Re: Docket No. 50-271 - Extended Power Uprate at Vermont Yankee Nuclear
Power Station

Please find enclosed for filing an original and two copies of the Vermont Department of Public Service Notice of Intention to Participate and Petition to Intervene with Exhibits, Affidavit of William K. Sherman, Notice of Appearance from Sarah Hofmann and Anthony Z. Roisman, and Certificates of Service.

**Docket No. 50-271
(Extended Power Uprate)**

Figure A-2. Conceptual Multiple Region Insulation Debris Model

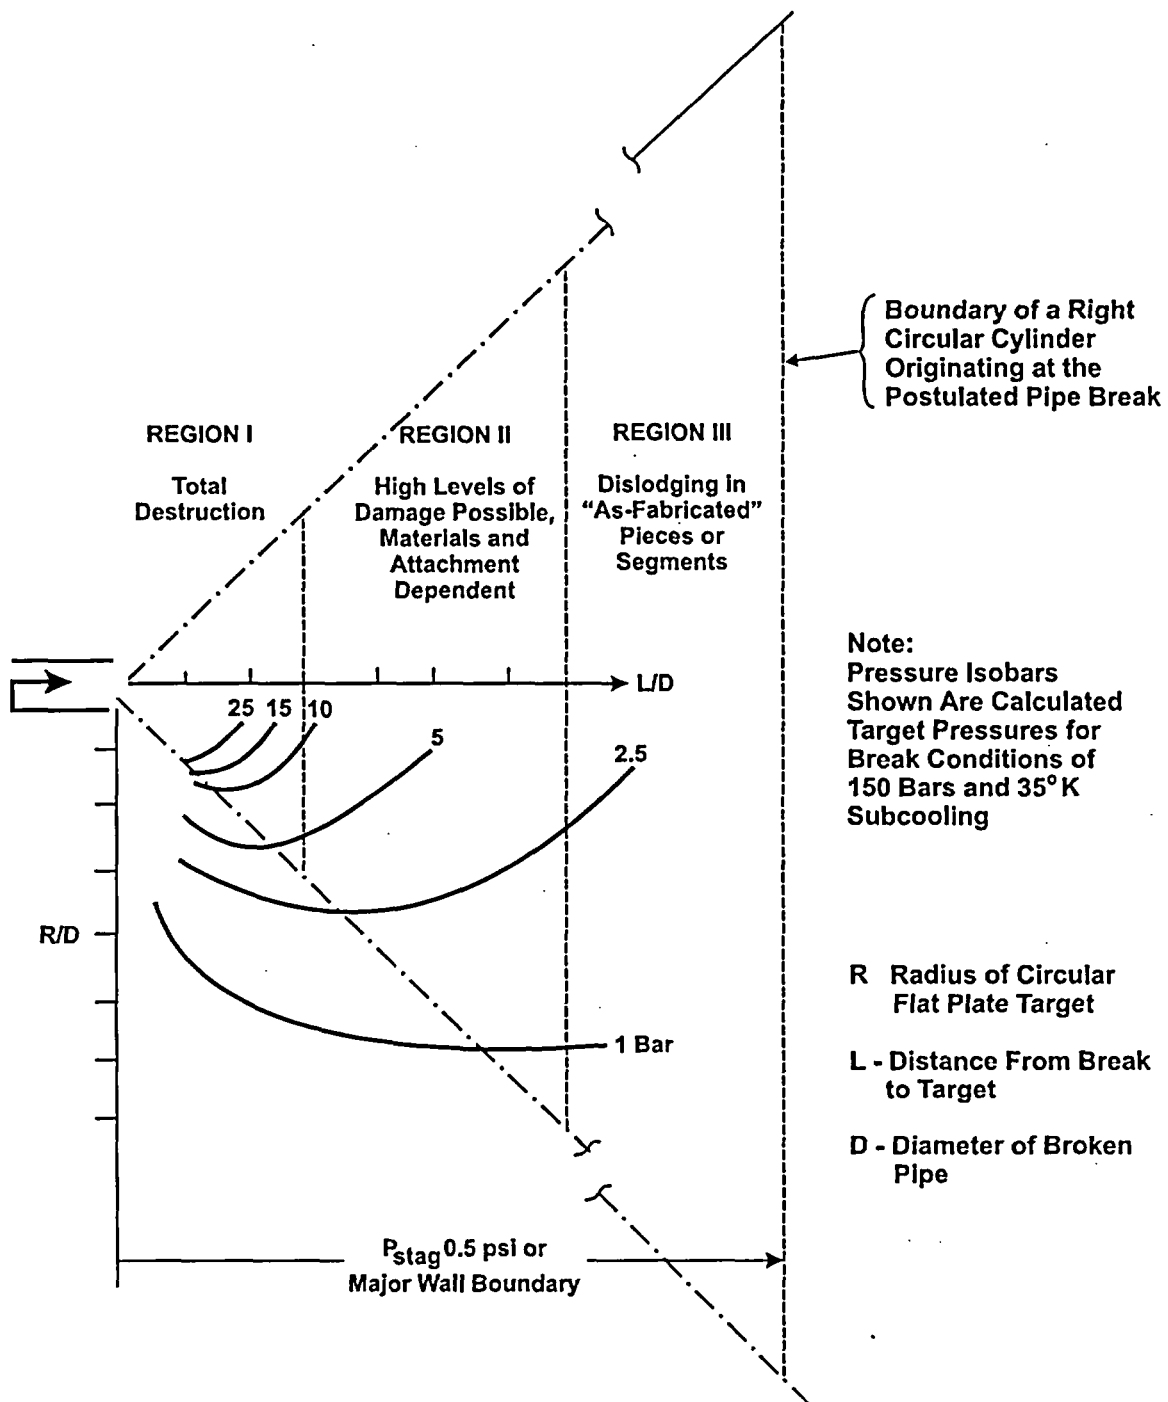
MEMBER WALLIS: This three-region two-phase conical jet model, with numbers on it Figure 17, comes from -- doesn't come from the Sandia work. It doesn't come from the one you referenced. The only place that I could find it was in a later new Reg [sic - NUREG] that the agency prepared.

16 MEMBER WALLIS: I'm saying that as a
17 debris model for your Figure A-2, that says that after
18 you get to a seven or something, the stagnation
19 pressure's only half the psi.

25 MEMBER WALLIS: Figure A-2, the somewhat

1 notorious Figure A-2. It says that there isn't a L
2 over D number on there, I think it's about seven is
3 down to a half a psi.

Figure 2.1-1
RHR Pump Allowable Operating Periods @ NPSHa Specified

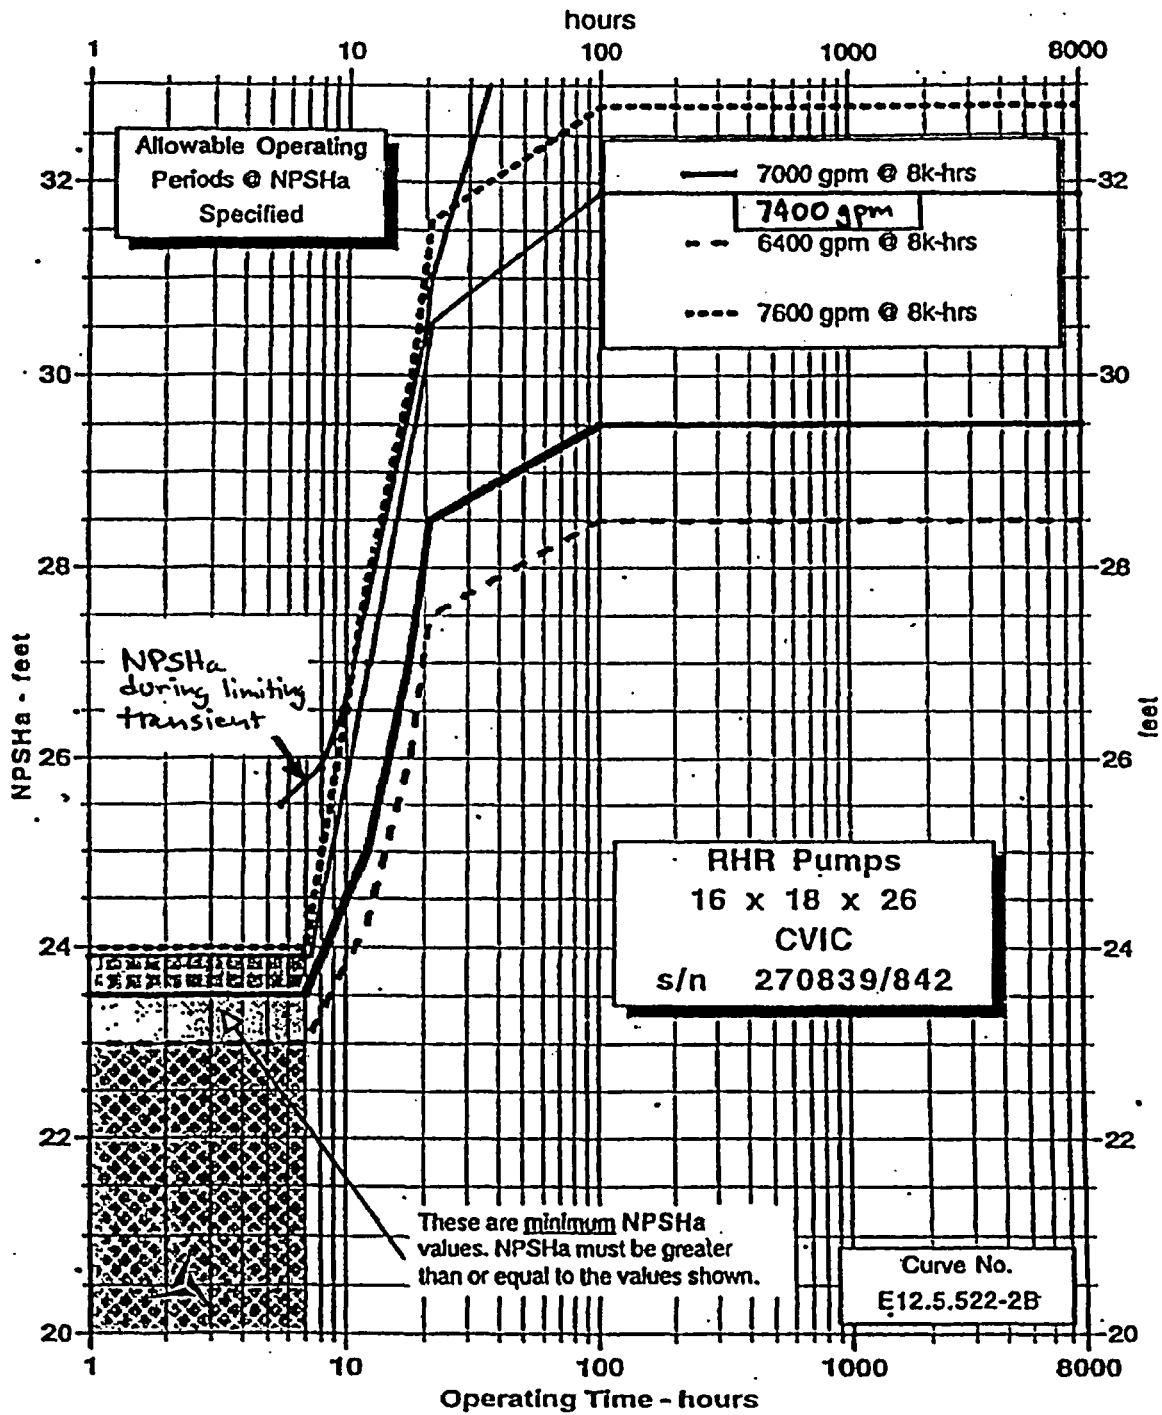
Section 4- Revise text referencing Figure 2.1-1 and 2.1.2 of Attachment 3 to calculation VYC-0808 to state that figures provide a plot of *Allowable Operating Periods @ NPSHa Specified* values for various flow rates not *NPSHr*

Figure 4-6
Overpressure Required for NPSH DBA LOCA – Long-Term

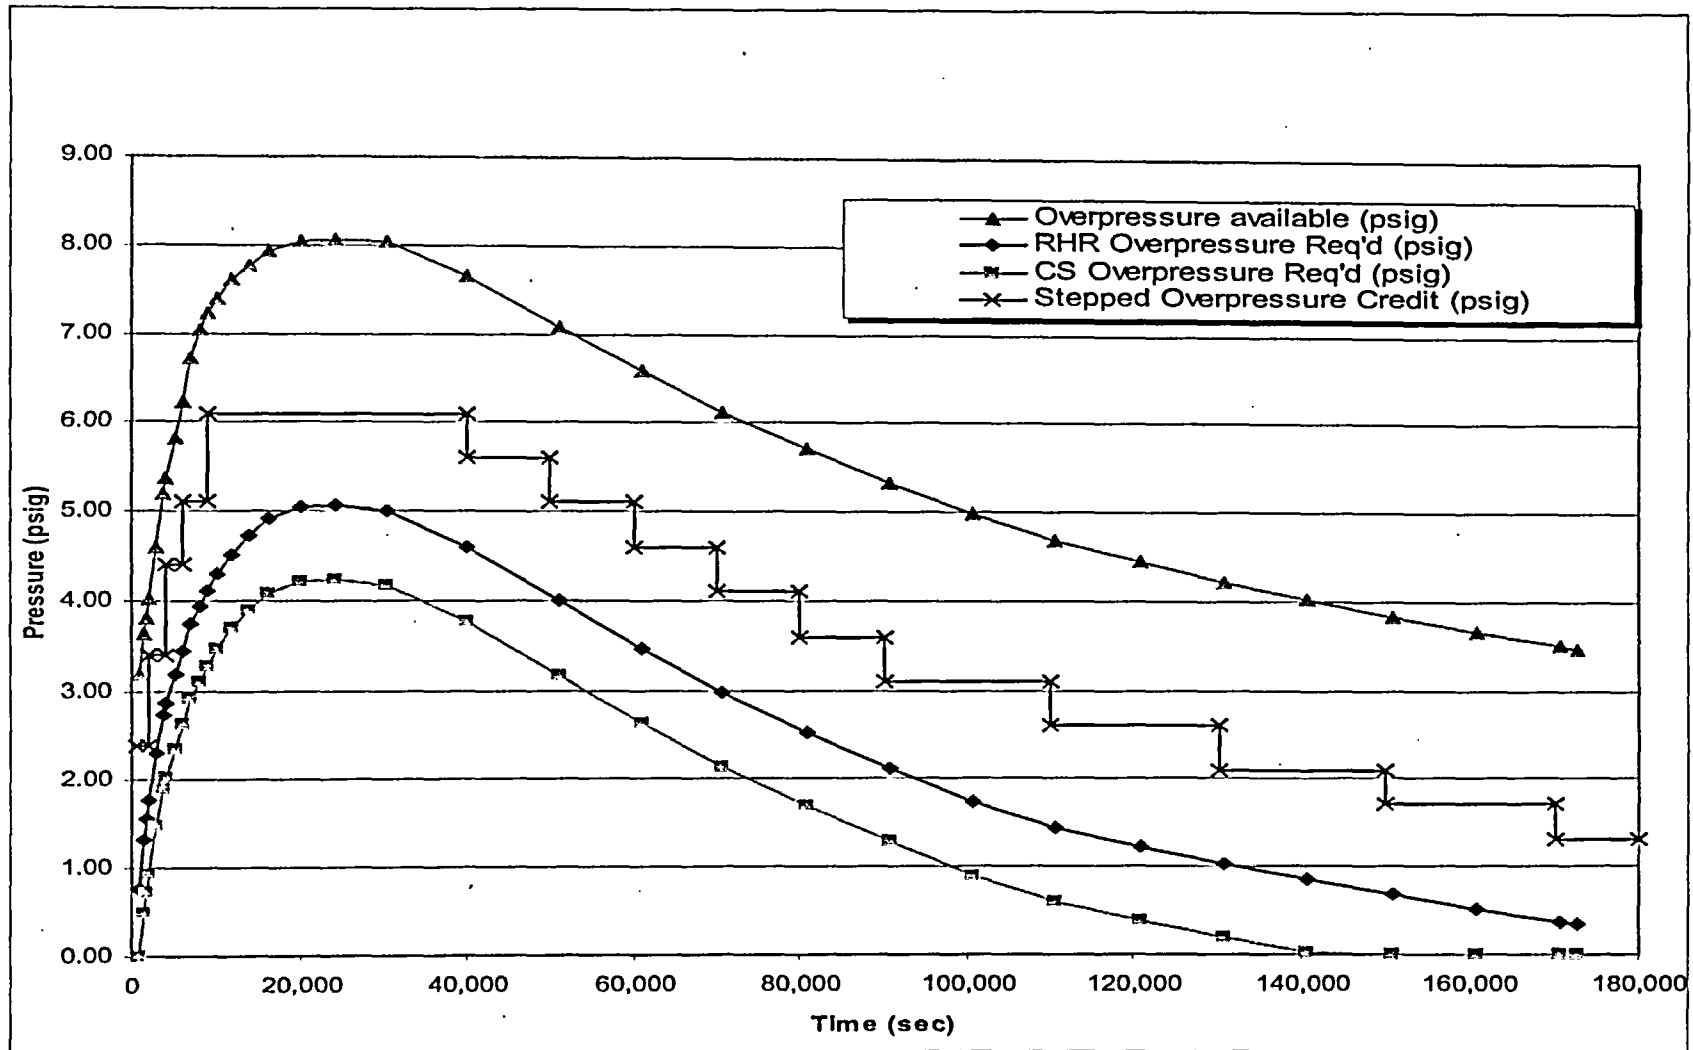
- e. VY PUSAR Table 4-2 and Figure 4-6 identify that containment accident pressure credit is taken for a period over two days after an accident. Since this constitutes the use of the reactor containment in a new manner, i.e., as an engineered safety feature to guarantee a minimum level of pressure over a 50 hour period, is additional containment pressure testing required to demonstrate pressure will be maintained for that period?

VY PUSAR Table 4-2 and Figure 4-6 identify that containment accident pressure credit is taken for a period over two days after an accident. Since this constitutes the use of the reactor containment in a new manner, i.e., as an engineered safety feature to guarantee a minimum level of pressure over a 50 hour period, is additional containment pressure testing required to demonstrate pressure will be maintained for that period?

The application dated September 10, 2003 (Reference 1), Attachment 6, Table 4-2 and Figure 4-6, show that the containment accident pressure requested for adequate available NPSH is 1.3 psig at 50 hours. When is containment accident pressure no longer required?

Based on the above, VYNPS is requesting approval of the "stepped" overpressure credit shown in Table 4-2 and Figure 4-6 to meet DBA LOCA long-term NPSH requirements.

Figure 4.2

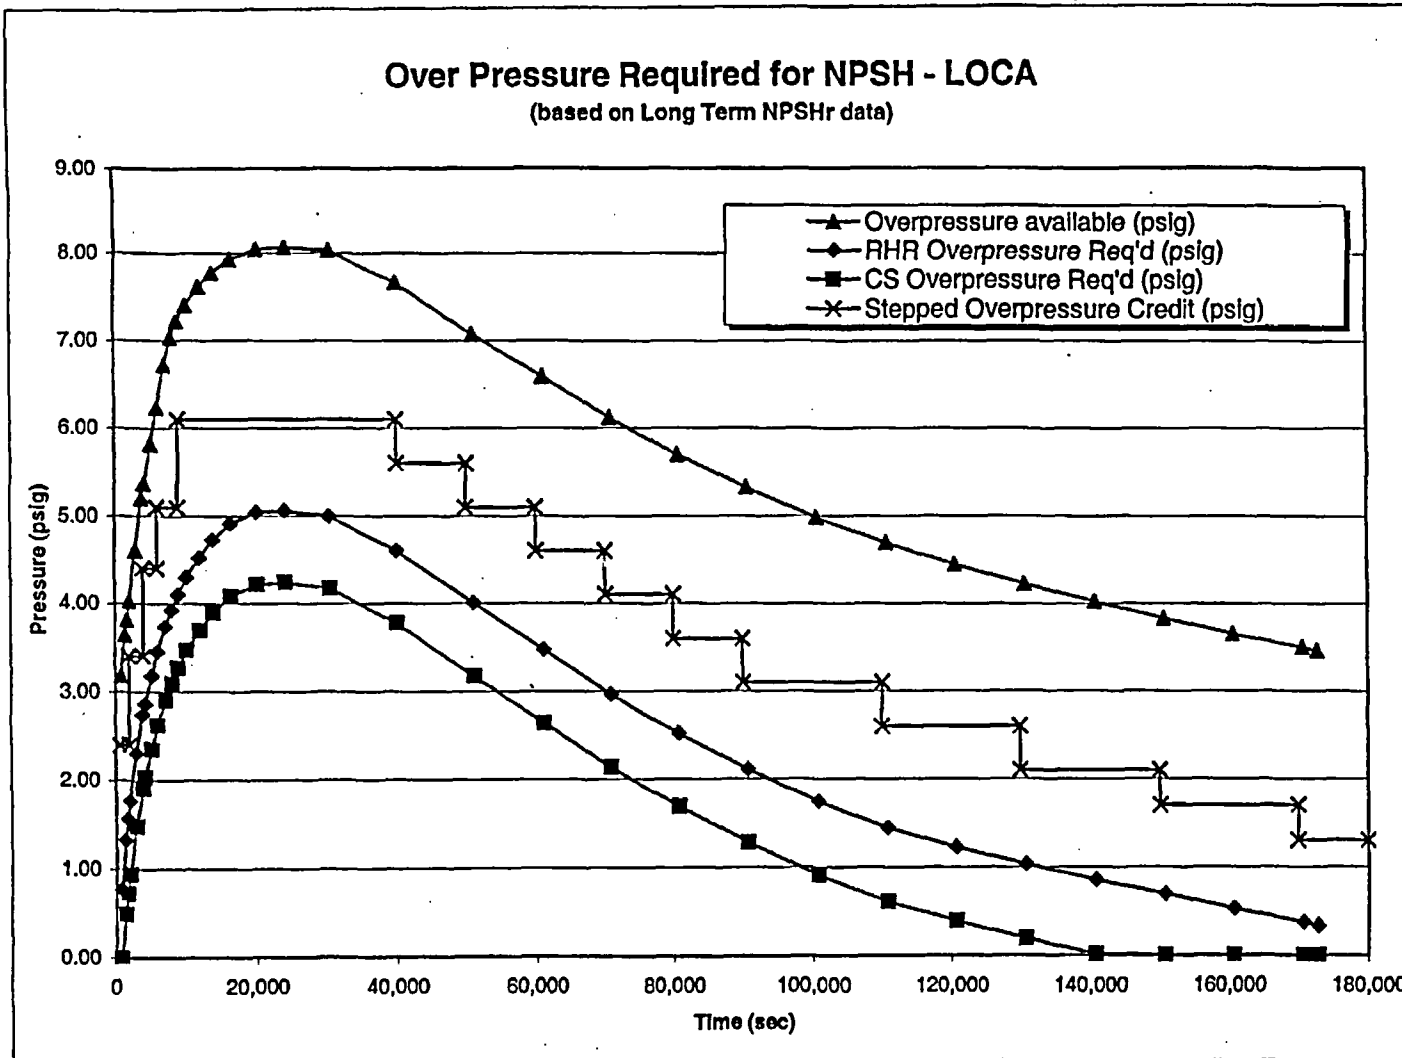
1852	Fig 4.2	<p style="text-align: center;">Over Pressure Required for NPSH - LOCA (based on Long Term NPSHr data)</p> <p>The graph displays four data series over a time period of 0 to 180,000 seconds. The Y-axis represents Pressure in psig, ranging from 0.00 to 8.00. The X-axis represents Time in seconds, ranging from 0 to 180,000. The series are: Overpressure available (psig) (triangles), RHR Overpressure Req'd (psig) (diamonds), CS Overpressure Req'd (psig) (squares), and Stepped Overpressure Credit (psig) (crosses). All series show a rapid increase in pressure within the first 20,000 seconds, reaching a peak, and then a gradual decline. The available overpressure starts at approximately 8.0 psig and decreases to about 3.5 psig at 180,000 seconds. The required overpressures for RHR and CS start at approximately 4.0 psig and decrease to about 0.5 psig and 0.2 psig respectively at 180,000 seconds. The stepped overpressure credit starts at approximately 3.0 psig and decreases to about 1.0 psig at 180,000 seconds.</p>

Figure 4.3

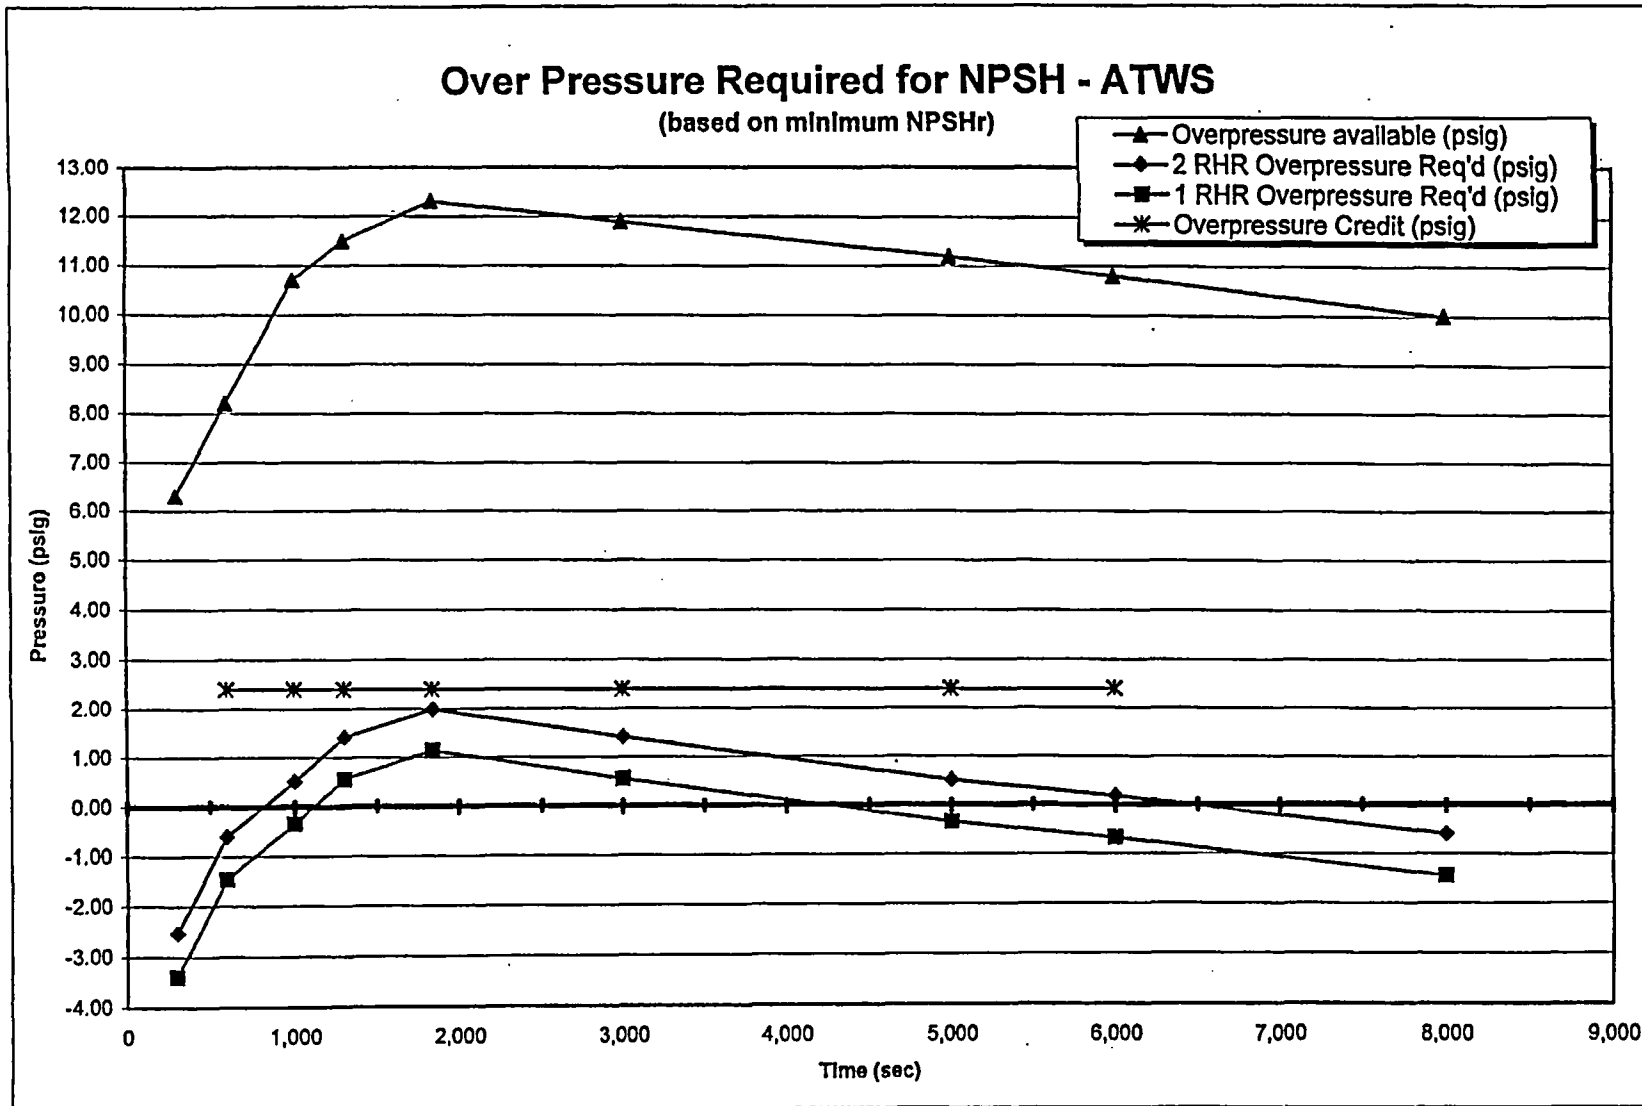
1853	VYC-0808	Paul Rainey	Fig. 4.3, base on 1 RHR pump per loop.	Refer to response to comment 1847.	Resolution accepted. B. Slifer 8/12/03

Comment #	CCN Section	Excerpt																																																		
1847	Fig 4.3	<div><p style="text-align: center;">Over Pressure Required for NPSH - ATWS (based on minimum NPSHr)</p><table border="1"><caption>Approximate data points from Fig. 4.3</caption><thead><tr><th>Time (sec)</th><th>Overpressure available (psig)</th><th>2 RHR Overpressure Req'd (psig)</th><th>1 RHR Overpressure Req'd (psig)</th><th>Overpressure Credit (psig)</th></tr></thead><tbody><tr><td>0</td><td>6.2</td><td>-2.5</td><td>-3.5</td><td>2.4</td></tr><tr><td>1,000</td><td>10.8</td><td>-0.5</td><td>-1.5</td><td>2.4</td></tr><tr><td>2,000</td><td>12.2</td><td>0.0</td><td>1.1</td><td>2.4</td></tr><tr><td>3,000</td><td>11.8</td><td>-0.2</td><td>0.8</td><td>2.4</td></tr><tr><td>4,000</td><td>11.2</td><td>-0.5</td><td>0.5</td><td>2.4</td></tr><tr><td>5,000</td><td>10.8</td><td>-0.8</td><td>0.2</td><td>2.4</td></tr><tr><td>6,000</td><td>10.2</td><td>-1.0</td><td>0.0</td><td>2.4</td></tr><tr><td>7,000</td><td>9.8</td><td>-1.2</td><td>-0.2</td><td>2.4</td></tr><tr><td>8,000</td><td>9.2</td><td>-1.5</td><td>-0.5</td><td>2.4</td></tr></tbody></table></div>	Time (sec)	Overpressure available (psig)	2 RHR Overpressure Req'd (psig)	1 RHR Overpressure Req'd (psig)	Overpressure Credit (psig)	0	6.2	-2.5	-3.5	2.4	1,000	10.8	-0.5	-1.5	2.4	2,000	12.2	0.0	1.1	2.4	3,000	11.8	-0.2	0.8	2.4	4,000	11.2	-0.5	0.5	2.4	5,000	10.8	-0.8	0.2	2.4	6,000	10.2	-1.0	0.0	2.4	7,000	9.8	-1.2	-0.2	2.4	8,000	9.2	-1.5	-0.5	2.4
